UNITED STATES PATENT AND TRADEMARK OFFICE

10/583,653

Office Action Summary	Application No. 10/583,653	Applicant(s) BRODE ET AL.	
	Examiner QUYEN P. LEUNG	Art Unit 2874

DETAILED ACTION

FIG. 2

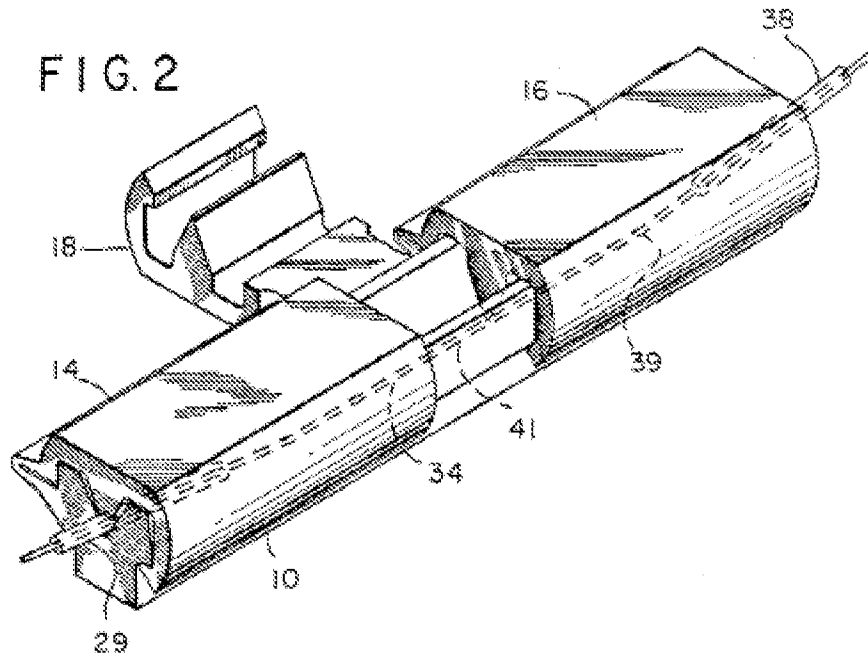
Re claim 38, see figures 2, 7 and 8 wherein the housing comprises at least two parts (top and bottom parts), with V-shaped grooves having been worked into a bottom part and a top part being configured to receive an inserted optical waveguide that is pushed into one of the V- shaped grooves when the bottom part and the top part are pushed together.

FIG. 7

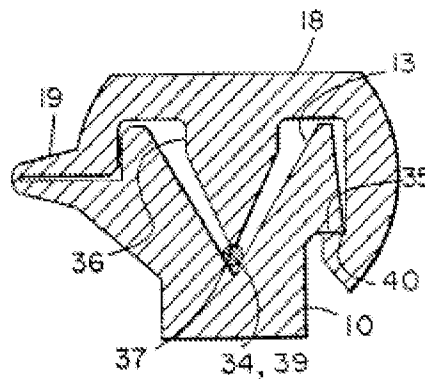
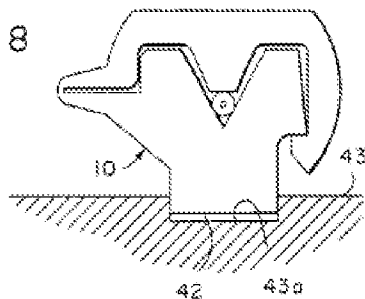
Re claim 37, see figures 7 and 8 wherein the fibre guidance structures (v-shaped grooves) are transient bores.

Re claim 40, see figure 7 wherein the reservoir 13 has been arranged in the top part 18.
